October 4, 2016

Re: HRC Elk River Report of Waste Discharge (ROWD) Amendment re: Sensitive Bedrock Terrain

Sensitive Bedrock Sub-Basin and Elk River Geologic Map

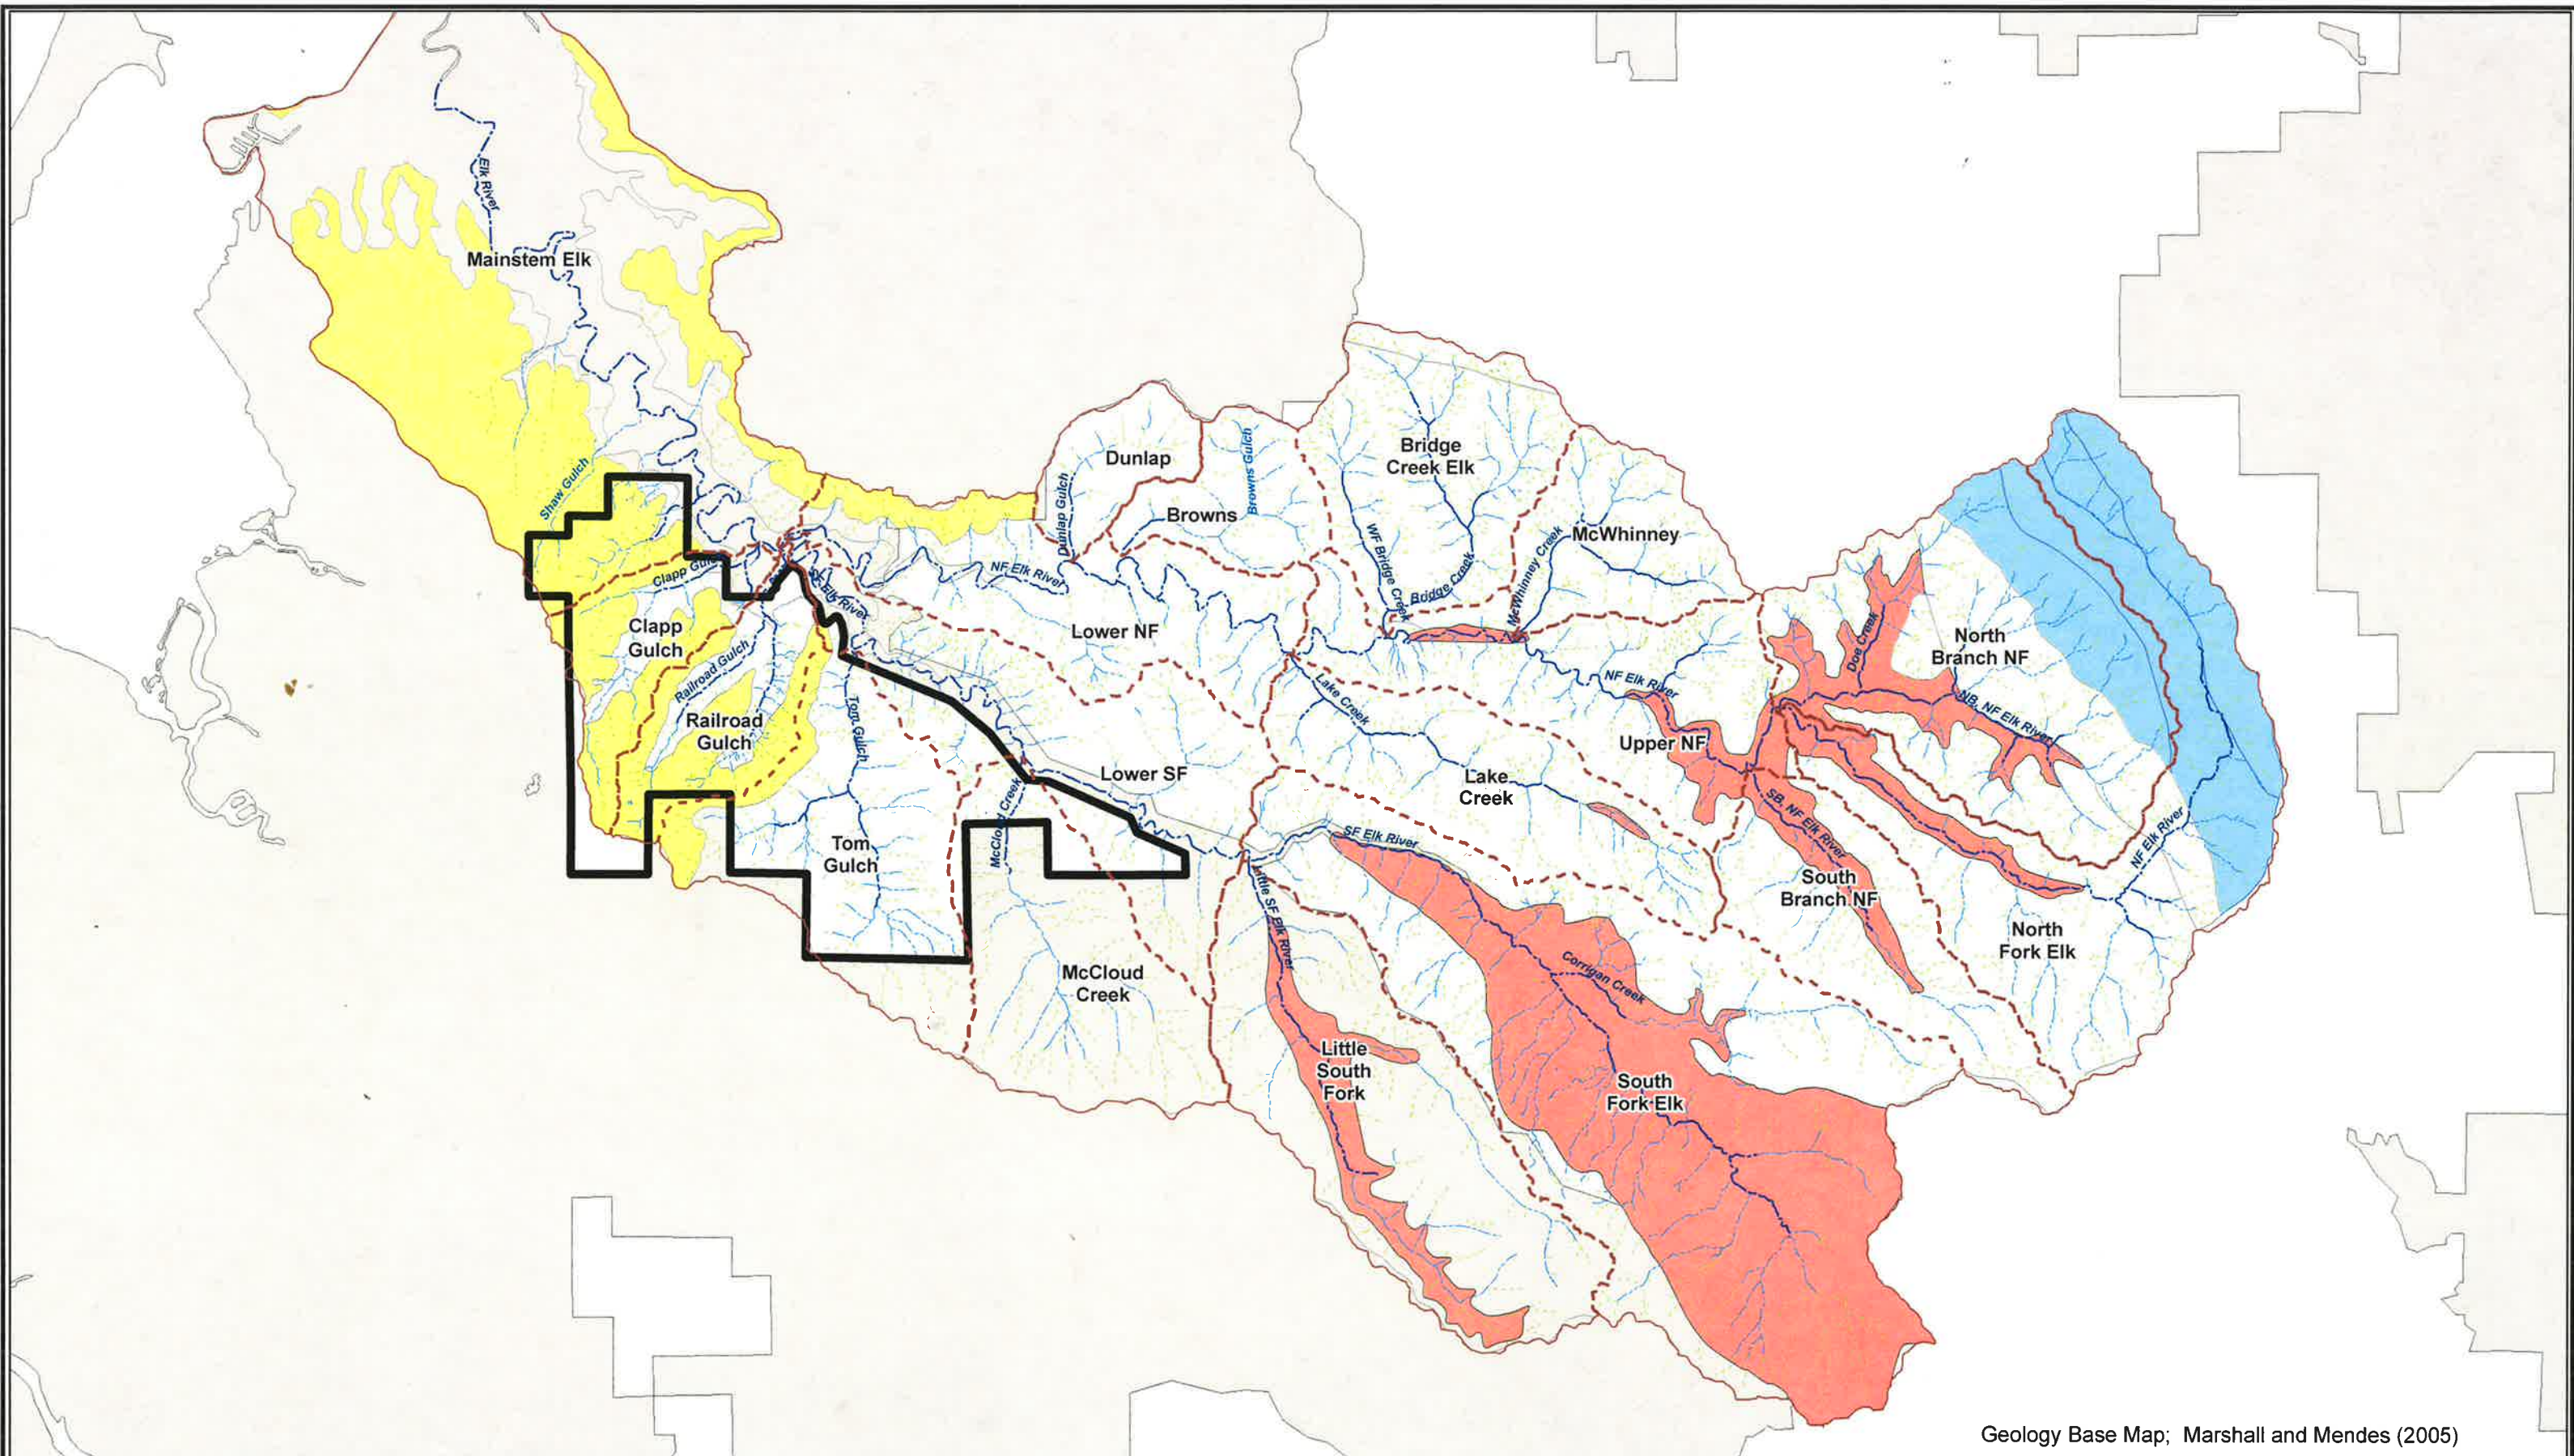
As we have discussed, there is a sixth sub-basin that should be incorporated into this *Sensitive Bedrock Terrain* (SBT) based on the presence of the same underlying geology. This sub-basin is referred to as the 'Mainstem Elk' and is located immediately north of Clapp Gulch. The published geologic map of the Elk River Watershed (Marshall and Mendes, 2005) identifies Hookton Formation sediments as prevalent throughout HRC's ownership in this sub-basin, and field surveys conducted by HRC staff confirm the presence of these Hookton sediments.

Hookton Formation sediments have been found to be more aerially extensive in the 'Tom Gulch' sub-basin, than noted on currently published geologic maps. Significant deposits were observed by licensed geologists in upland areas of this basin during implementation of road stormproofing activities (personal communications, HRC Forest Science Staff, 2012), THP geologic assessments (SDG, 2004; Oswald Geologic, 2007), and the implementation of daily duties (S. Beach). The composition of this material is analogous to that observed and mapped in the 'Clapp Gulch' and 'Railroad Gulch' sub-basins. Additional field surveys are likely to reveal the presence of Hookton Formation material in the 'McCloud Creek' sub-basin, and potentially that small region of the 'Lower South Fork' (SF) sub-basin situated above the southern bank of the South Fork Elk River. Consequently, these areas were included in the original delineation of the ROWD *Sensitive Bedrock Terrain* (SBT) and subject to the specific prescriptions detailed in Section 5.4 of the ROWD pending further investigation.

Conversely, the distribution of Hookton Formation deposits in the 'Lower North Fork' (NF) sub-basin is not as extensive as published maps indicate. Although present, they appear to be limited to upland slopes and not as predisposed to mass movements as those deposits located within the boundaries of the SBT identified on the attached figure (THP 1-02-103 HUM [Archers][RPF Disclosure Letter]; THP 1-08-072 HUM [Moss Elk][SDG, 2008]). Based on the site geology, geomorphic environment, and response to past land use activities we did not include these particular deposits in the original SBT delineation, or in this revision. Landslide hazards in these areas are significantly lower than those attributed to deposits present in the 'Clapp Gulch', 'Railroad Gulch' (Railroad Gulch Effectiveness Project), or 'Tom Gulch' sub-basins. Please also note the revised delineation of the SBT, as shown on the attached figure, excludes the portion of the 'Lower SF' sub-basin located north of the South Fork Elk River. Extensive geologic investigation has found no Hookton sediments present in this area.

HRC is submitting this revision (amendment) to its ROWD (Section 5.4) to more accurately reflect on ground geologic conditions warranting special consideration and to assist in the development of site-specific, process-based watershed-wide waste discharge requirements (WWDRs). The net effect of this change is the addition of HRC's entire 320 acre ownership within the 'Mainstem Elk' sub-basin, and the limiting of the Lower SF sub-basin to those areas where Hookton Formation could still be found (307 acres).

Reflecting these changes, the SBT shown on the attached figure totals 3,321 acres, including all of HRC's ownership in the Mainstem Elk, Clapp Gulch, Railroad Gulch, Tom Gulch, and McCloud Creek sub-basins, and all portions of the Lower SF sub-basin located south of the South Fork Elk River. This is a net change of 13 additional acres in the SBT compared to the area originally submitted.
